Product/Process Change Notice(PCN)

PCN#: 10002 **Date:** February 19, 2016

Product Identification:
BC-2003, BC-2003-TR

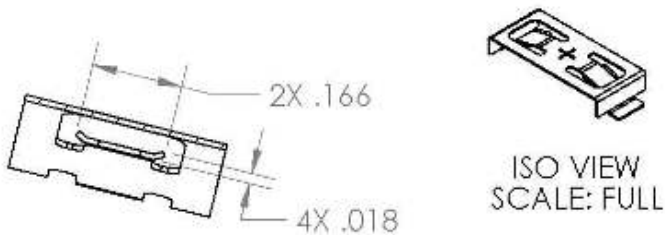
Category Change: PCB layout unchanged, body width increased by 0.05" to accommodate redesigned pressure contacts chamfer.

- Product Mark
- Date Code
- Other: Chamfer added to pressure contacts

Demonstrated or Anticipated Impact on Form, Fit, Function or Reliability: Increased usability with clients able to insert coin cell easier.
